8th Edition (2023) Florida Building Code

Proposed Code Modifications

ELECTRICAL

E10220

FIGURE 905.1.2 ICE BARRIERS

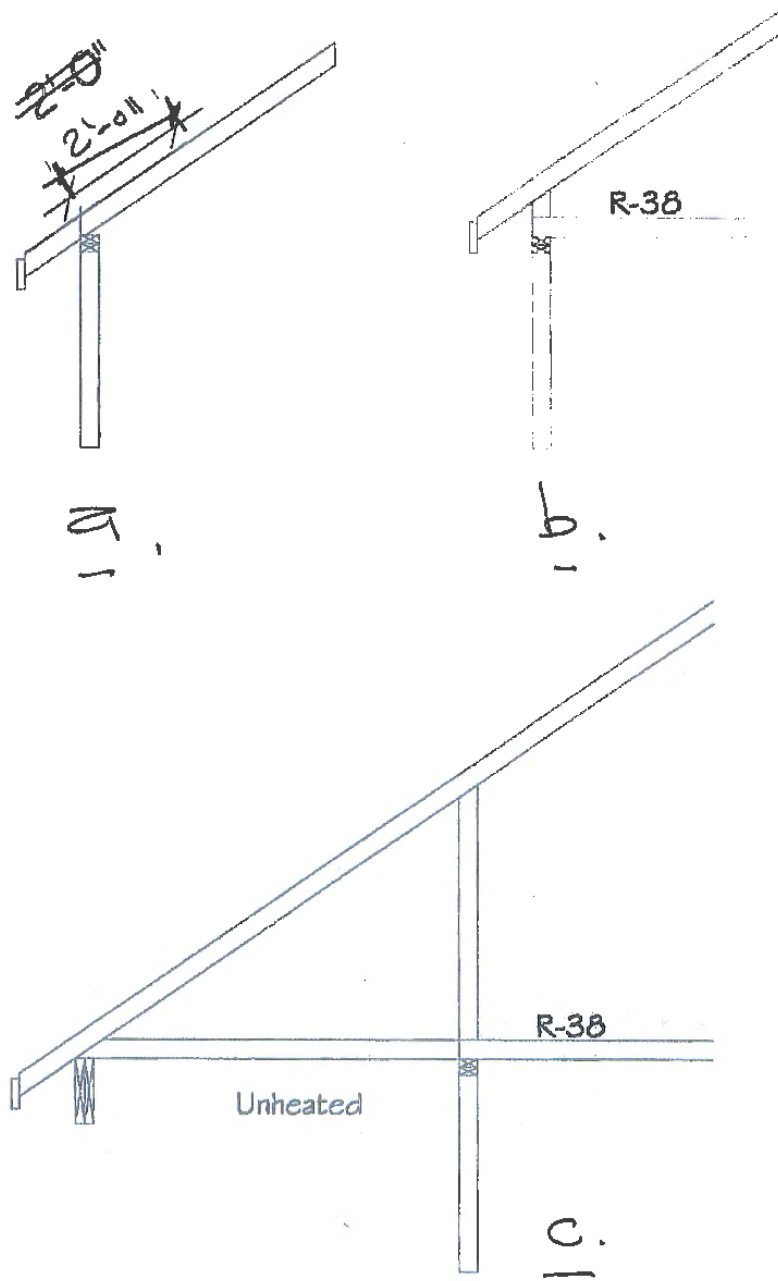
FOR OFFICE USE ONLY			
Received 11/16/2018	Code 2018 IRC	Proposal number #355	
Code title International Residential Code		Edition 2018	
Section number and title R905.1.2 Ice barriers		Page Number	
Proponent Bill Kauffholz		Representing (if applicable) Fischer Homes	
Address (number and street, city, state, and ZIP code)		Telephone number	
PROPOSED CODE CHANGE (check one)			
<input type="checkbox"/> Change to read as follows <input type="checkbox"/> Add to read as follows <input checked="" type="checkbox"/> Delete and substitute as follows <input type="checkbox"/> Delete without substitution			
<p>R905.1.2 Ice barriers</p> <p>An ice barrier shall be installed for asphalt shingles, metal roof shingles, mineral-surfaced roll roofing, slate and slate-type shingles, wood shingles and wood shakes. The ice barrier shall consist of not fewer than two layers of underlayment cemented together, or a self-adhering polymer-modified bitumen sheet shall be used in place of normal underlayment and extend from the lowest edges of all roof surfaces to a point not less than 24 inches (610 mm) outside the exterior wall line of the building. The 24 inch measurement shall be along the slope of the roof from the point where the projected outside face of the wall intersects the roof deck. See Figure 905.1.2 (a). On roofs with slope equal to or greater than eight units vertical in 12 units horizontal (67-percent slope), the ice barrier shall also be applied not less than 36 inches (914 mm) measured along the roof slope from the eave edge of the building.</p> <p>Exception 1: Detached accessory structures not containing conditioned floor area</p> <p>Exception 2: If an attic/roof section is insulated to a minimum of R-38 uncompressed over the outside face of the exterior wall</p> <p>See pg. 2 for Figure 905.1.2 Ice barriers</p>

FIGURE 905.1.2 ICE BARRIERS

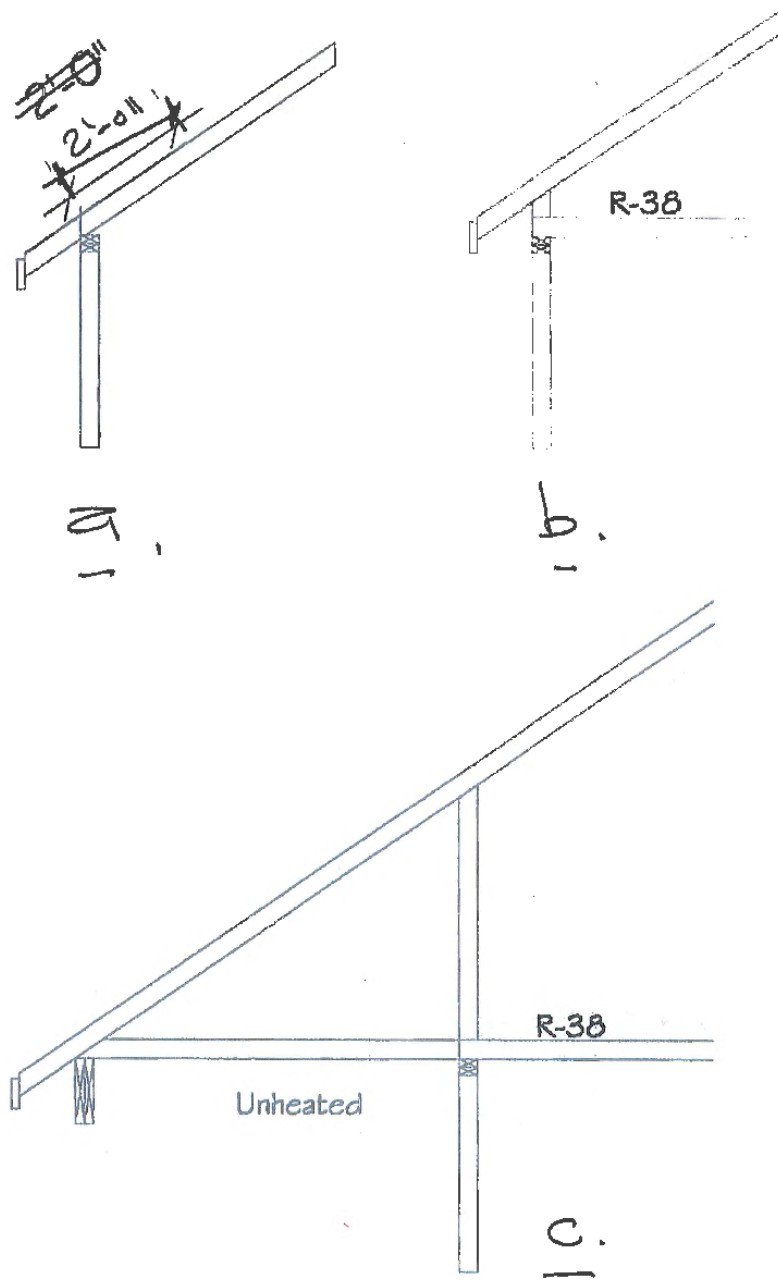
FOR OFFICE USE ONLY			
Received	11/16/2018	Code	2018 IRC
		Proposal number	#355
Code title		Edition	
International Residential Code		2018	
Section number and title		Page Number	
R905.1.2 Ice barriers			
Proponent		Representing (if applicable)	
Bill Kauffholz		Fischer Homes	
Address (number and street, city, state, and ZIP code)		Telephone number	
PROPOSED CODE CHANGE (check one)			
<input type="checkbox"/> Change to read as follows <input type="checkbox"/> Add to read as follows <input checked="" type="checkbox"/> Delete and substitute as follows <input type="checkbox"/> Delete without substitution			
<p>R905.1.2 Ice barriers</p> <p>An ice barrier shall be installed for asphalt shingles, metal roof shingles, mineral-surfaced roll roofing, slate and slate-type shingles, wood shingles and wood shakes. The ice barrier shall consist of not fewer than two layers of underlayment cemented together, or a self-adhering polymer-modified bitumen sheet shall be used in place of normal underlayment and extend from the lowest edges of all roof surfaces to a point not less than 24 inches (610 mm) outside the exterior wall line of the building. The 24 inch measurement shall be along the slope of the roof from the point where the projected outside face of the wall intersects the roof deck. See Figure 905.1.2 (a). On roofs with slope equal to or greater than eight units vertical in 12 units horizontal (67-percent slope), the ice barrier shall also be applied not less than 36 inches (914 mm) measured along the roof slope from the eave edge of the building.</p> <p>Exception 1: Detached accessory structures not containing conditioned floor area</p> <p>Exception 2: If an attic/roof section is insulated to a minimum of R-38 uncompressed over the outside face of the exterior wall</p> <p>See pg. 2 for Figure 905.1.2 Ice barriers</p>
